ADDENDUM 1

ITB TDD 71-20

Destin Fort Walton Beach Convention Center Exterior Accessibility

This addendum is to extend bid opening, add additional bid documents, and answer questions provided by the vendors.

ED101

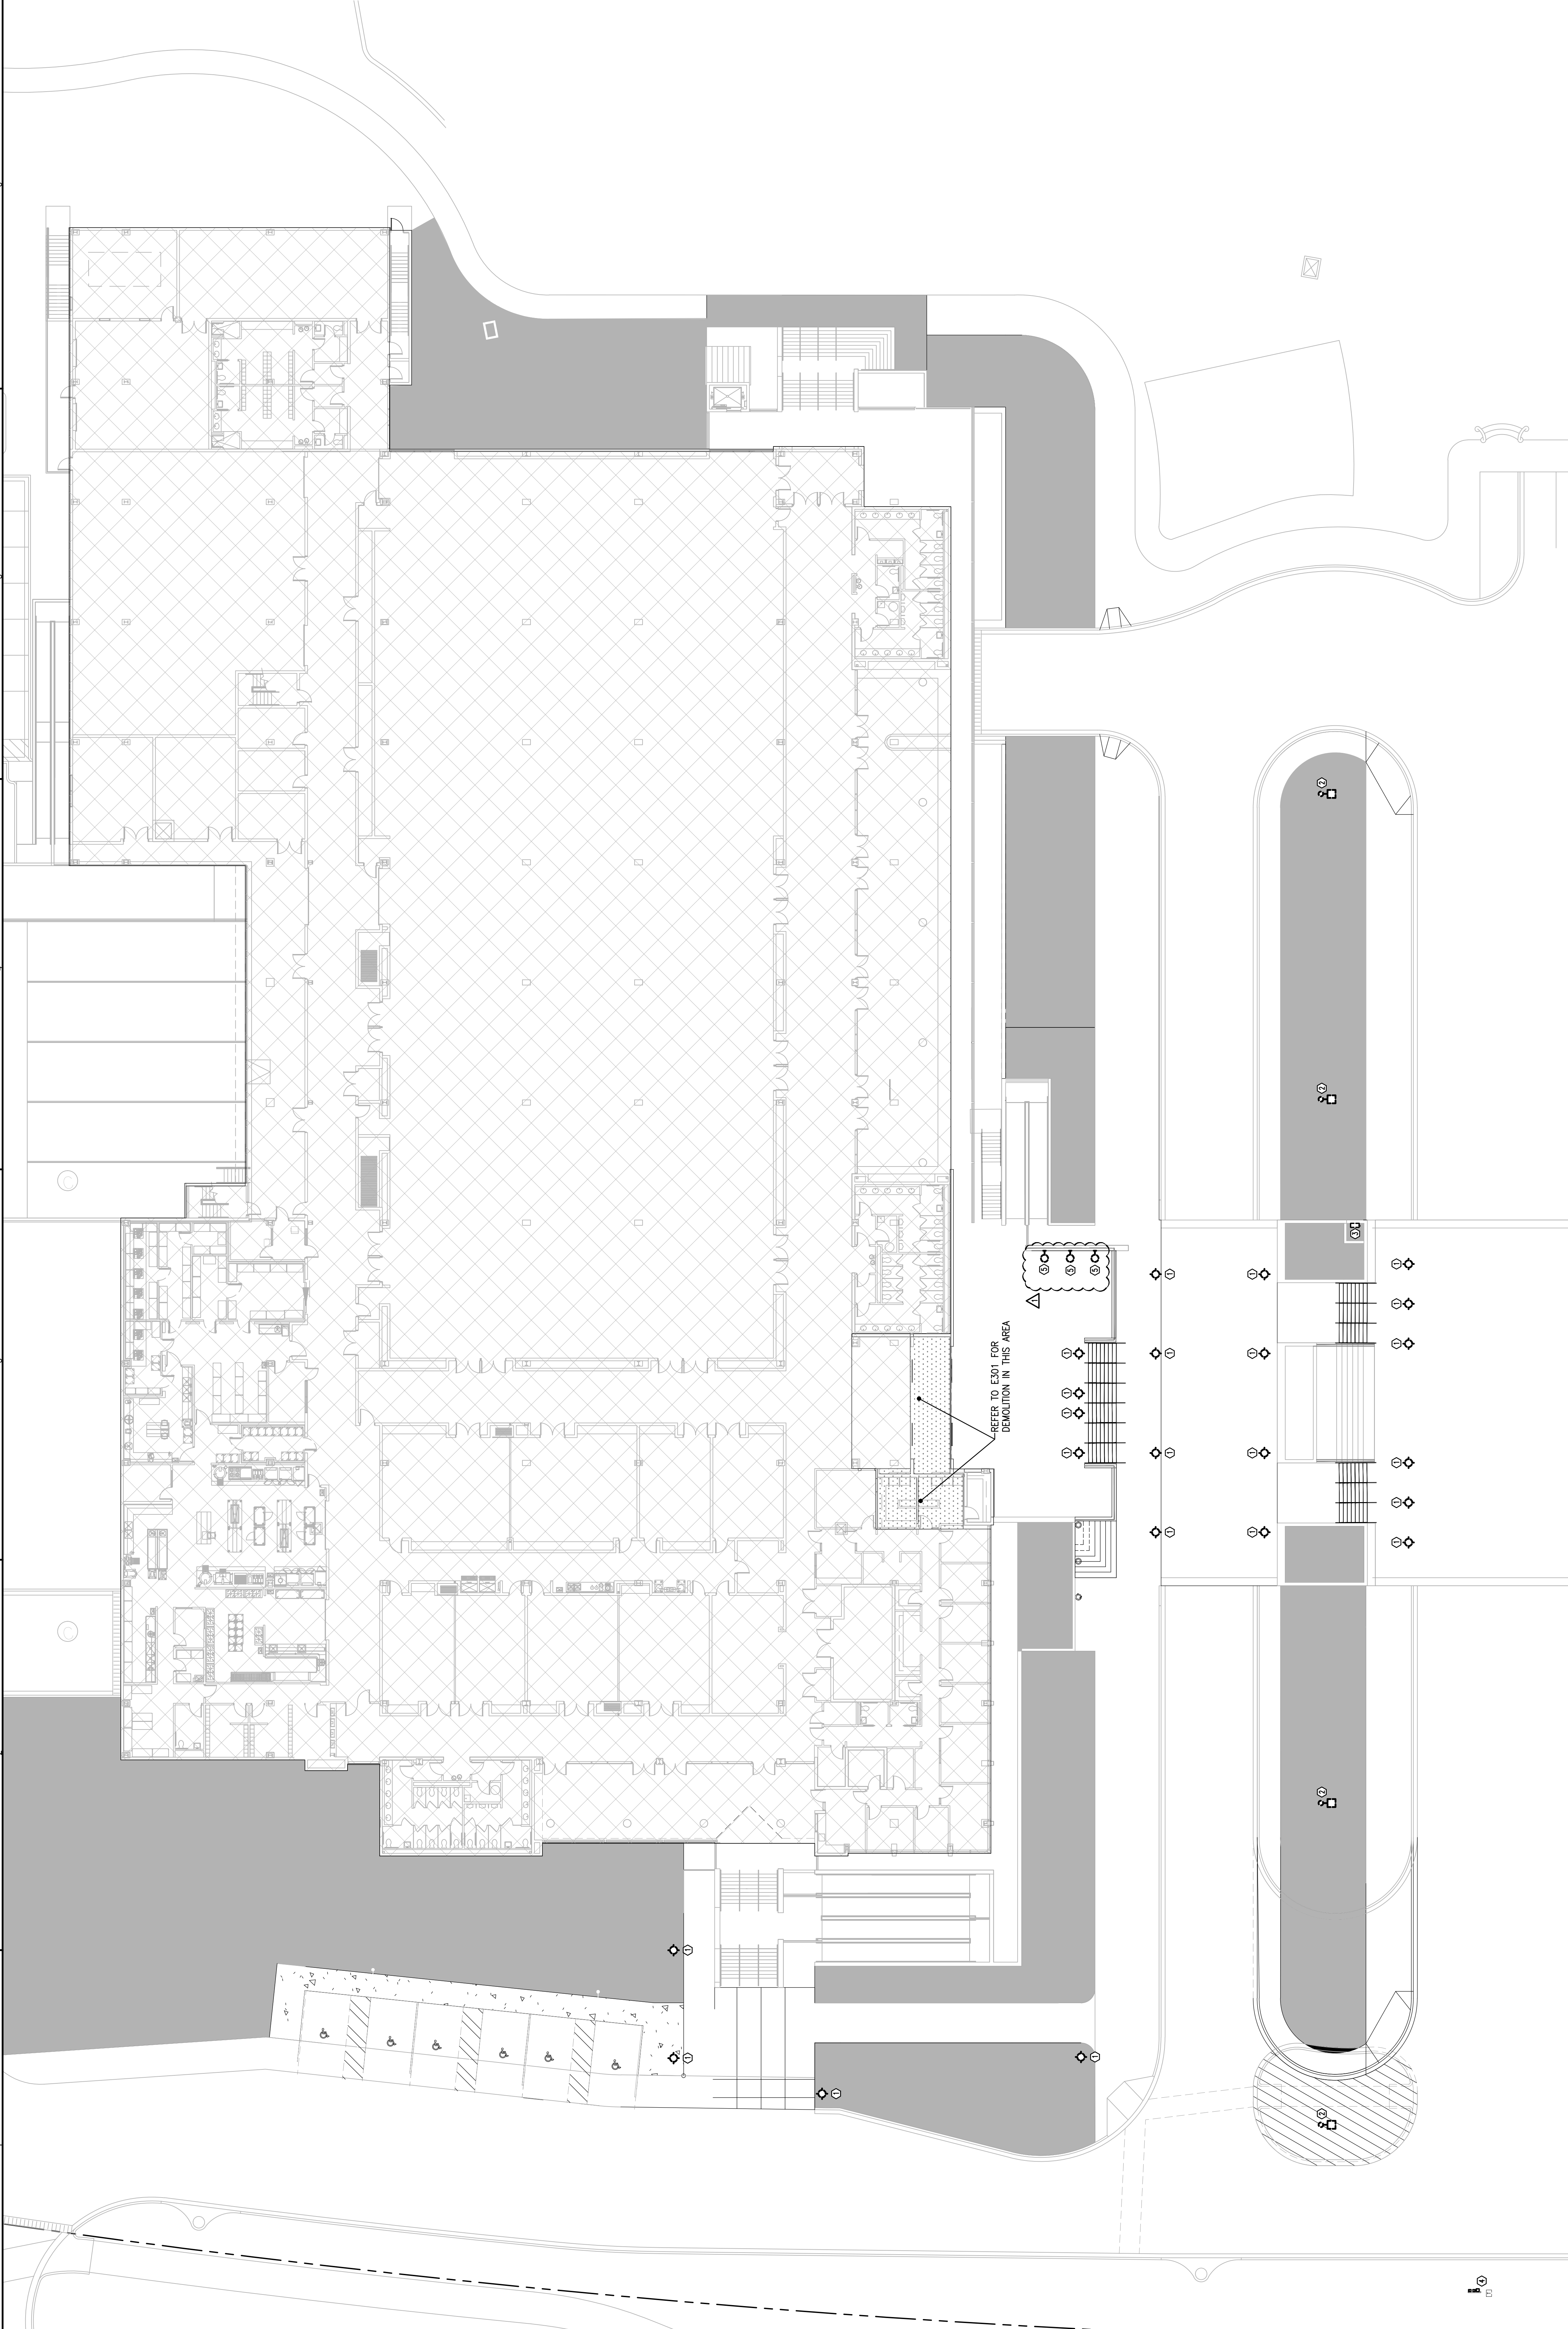
- Project Manual: Add Southern Earth Sciences: March 25, 2020, File No.: P20-0128, Geotechnical Investigation and recommendations.
- Prebid Conference Sign In Sheets: August 19, 2020.
- Sheet ED101: Add Note #5 "Remove Step Lights (3). Remove existing conductors and cap existing conduit."
- Existing Entry Conduit Photos

- NOTES**
- ① REMOVE BOLLARD. REMOVE EXISTING CONDUCTORS AND CAP EXISTING CONDUIT. ADD PAVERS TO MATCH EXISTING.
 - ② REMOVE FIXTURE, POLE AND POLE BASE. REMOVE EXISTING CONDUCTORS AND CAP EXISTING CONDUIT.
 - ③ REMOVE EXISTING FOUNTAIN CONDUCTORS AND CAP EXISTING CONDUIT.
 - ④ REMOVE METER, PANEL AND EXISTING CONDUCTORS BACK TO EXISTING TRANSFORMER. REPAIR BACKBOARD AS REQUIRED.
 - ⑤ EXISTING CONDUIT. REMOVE EXISTING CONDUCTORS AND CAP EXISTING CONDUIT.
